Notice of CPU Boards Changes

(For Use in the Hoisting Inverter of 400V/200V class U series)

Subject	Notice of CPU Boards Changes (For use in the Hoisting Inverter of 400V/200V class U series))	Date of issue	April 29, 2016	Notified to
		MITSUBISHI ELECTRIC FA INDUSTRIAL PRODUCTS CORPORATION 1-1-1 Imajuku-Higashi, Nishi-ku, Fukuoka 819-0192 TEL 092-805-3631		Sales agent

CPU board	Source voltage	Existing Product		Switching Product		Remarks
		Part Code	Drawing. No	Part code	Drawing. No	
	200V class	03G540	P145619G01	03G547	PA01139G01	All models
	400V class	03G54K	P147425G01	03G571	PA01140G01	5 t and under

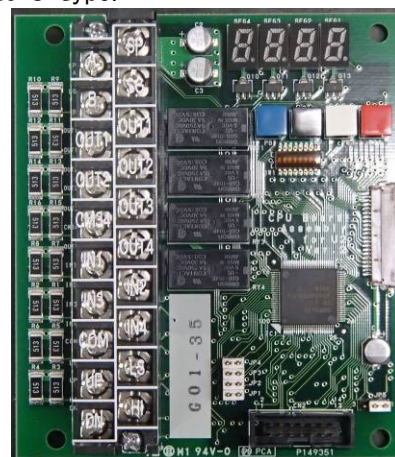
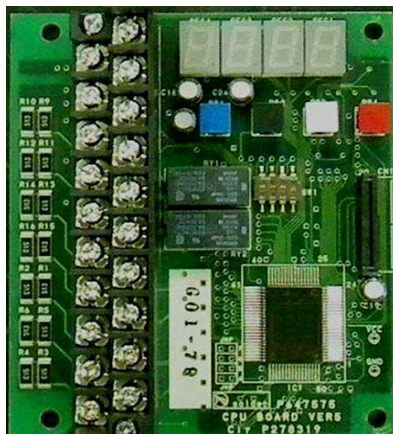
- (1) The function of error detection output and operation status output are equipped as standard.
- (2) It is possible to inspect the number of starting times and the operation time at fault occurrence.
- (3) It is possible that to set the frequency per 0.1Hz when the frequency is 10Hz and under.
- (4) The improved sinusoidal modulus makes low noise.
- (5) Switched product is compatible with existing product.
- (6) **Ensure that a wire is rewired, and set the function selector switch when replacing a board.**
- (7) Refer to the Instruction Manual about details and setting of additional functions.
- (8) Combined hoisting operation is impossible due to U type.
